Meeting Minutes

Project: I-29 Exit 77 (41st Street) Interchange Study and Environmental Assessment

Subject: Carolyn Avenue Alternatives

Figure
C-4

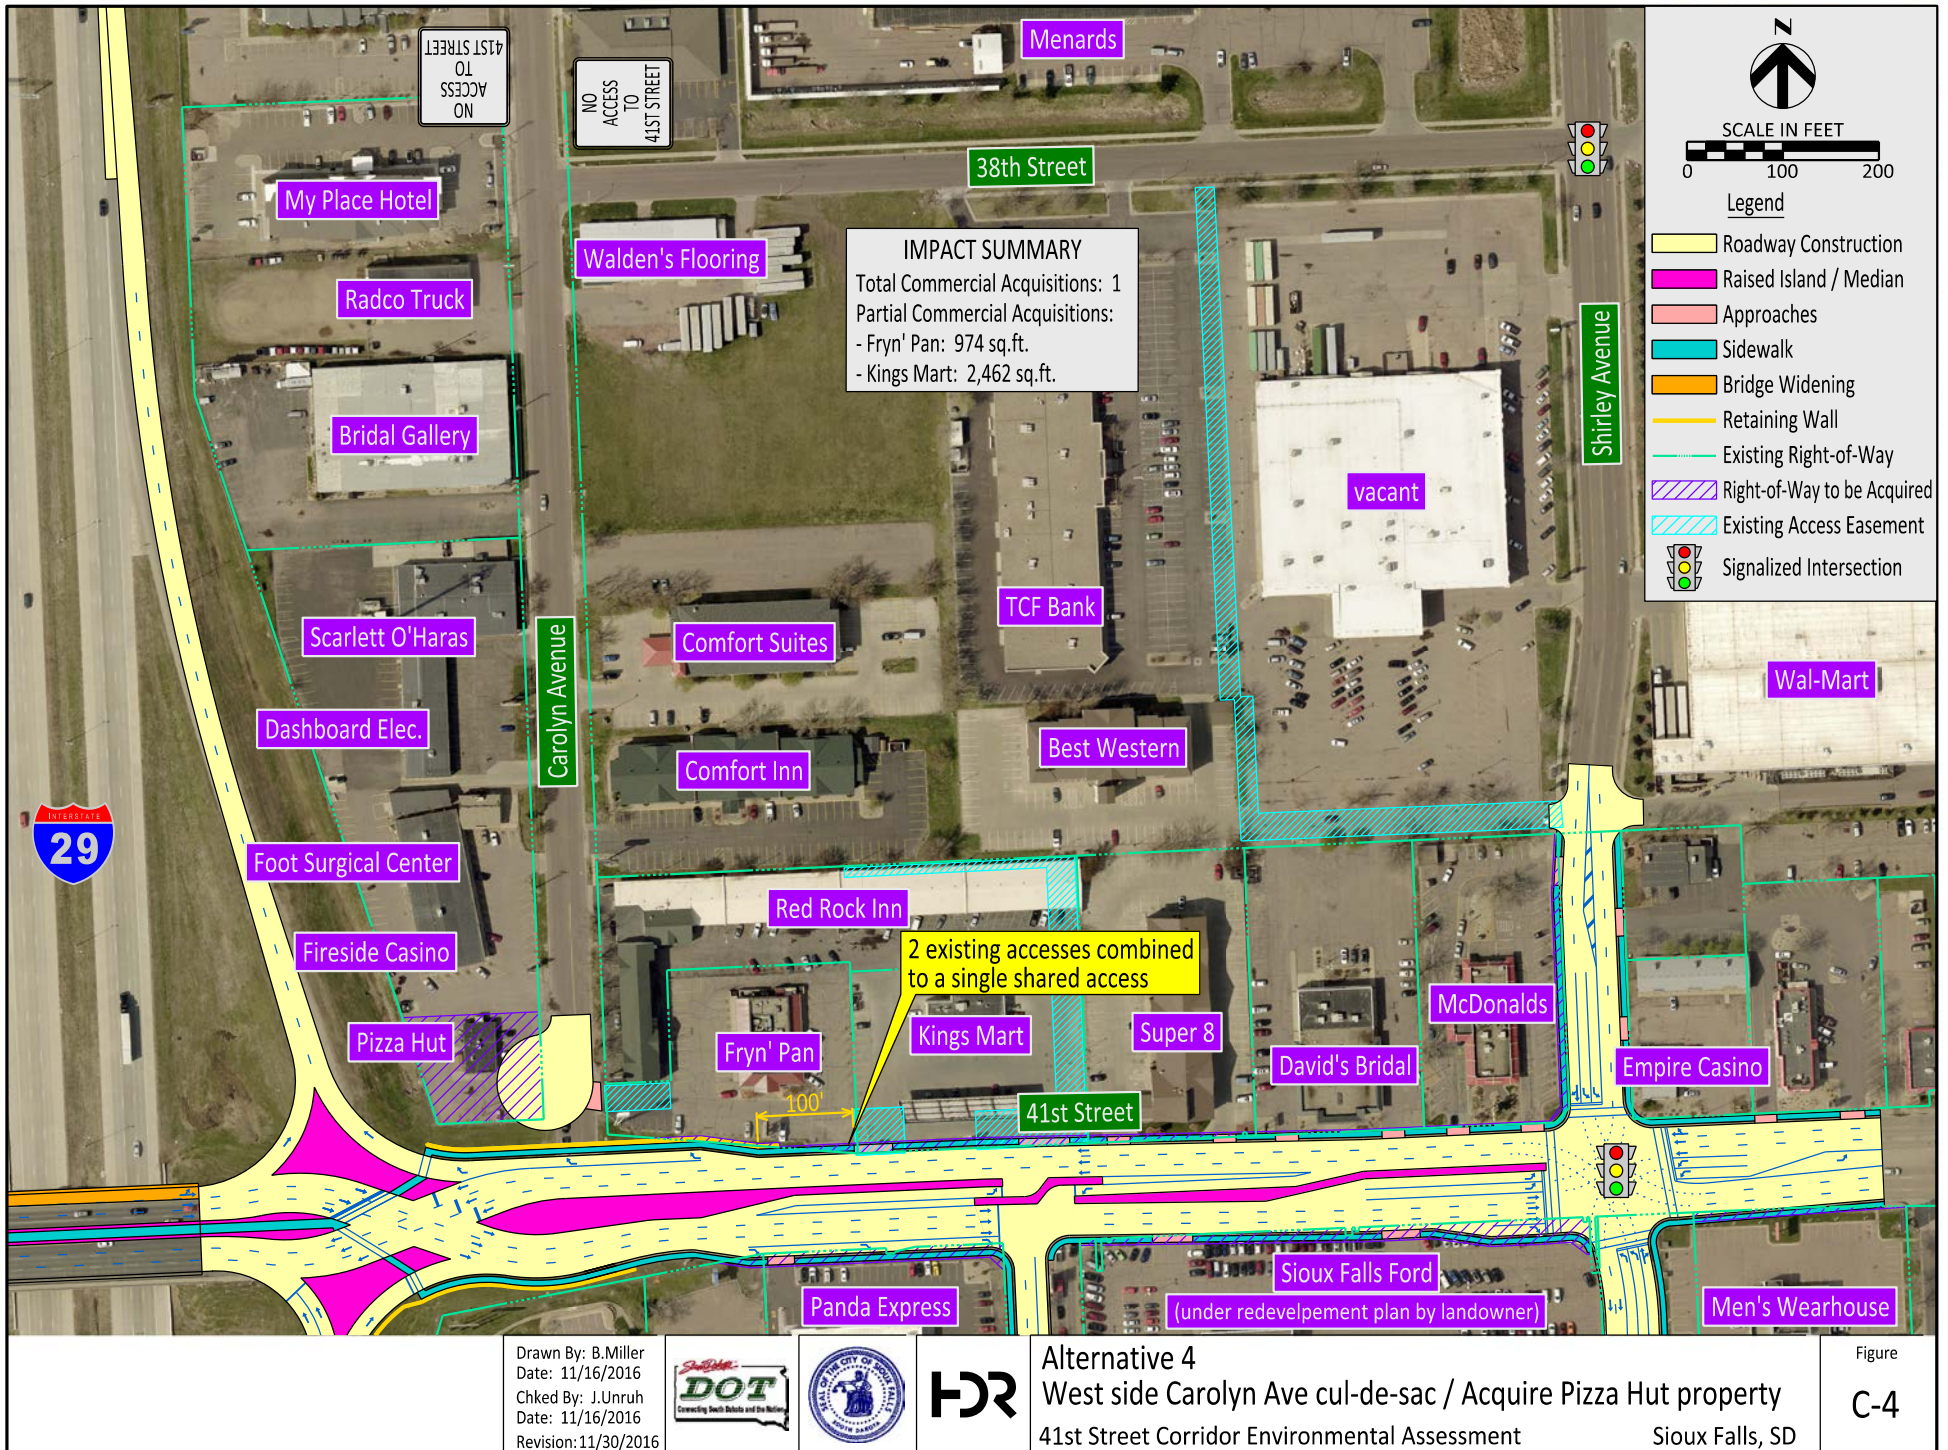
- "No Access to 41st Street" signs were added to Alternatives 3, 4, and 5 (right-in only and cul-de-sac).
- 2.2 Discussion resulted in these proposed design features for the Carolyn Avenue Alternatives (see **Attachment 1**).

Figure
C-6

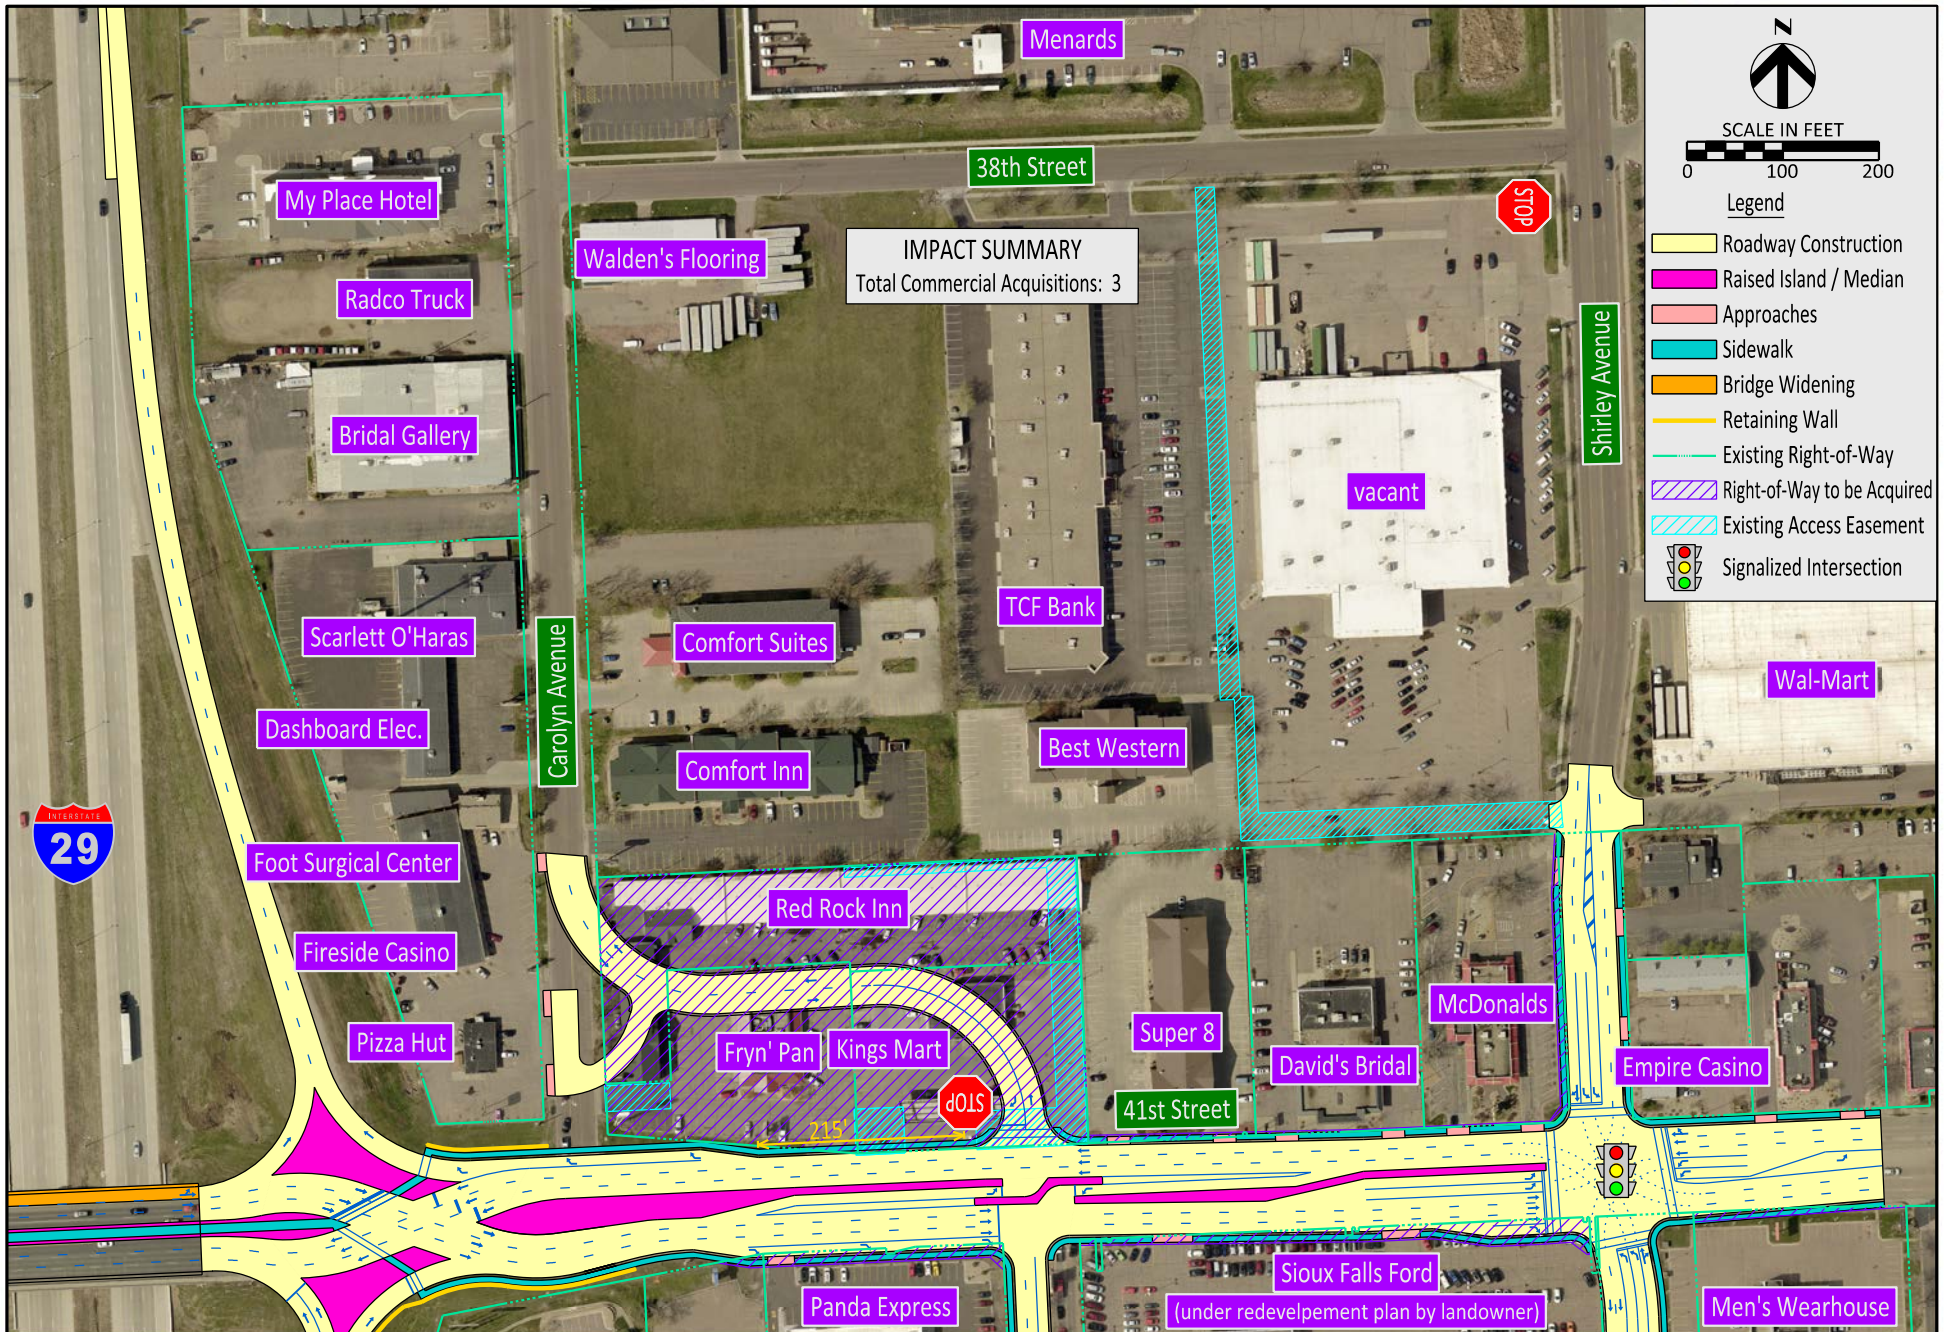
- Add Alternative 6 with realignment of right-in/right-out Carolyn Avenue and acquisition of Red Rock Inn, Fryn' Pan, and Kings Mart properties. This is likely the only way that adequate separation from the interchange ramp could be provided. FHWA would probably only approve this $\frac{3}{4}$ access alternative.
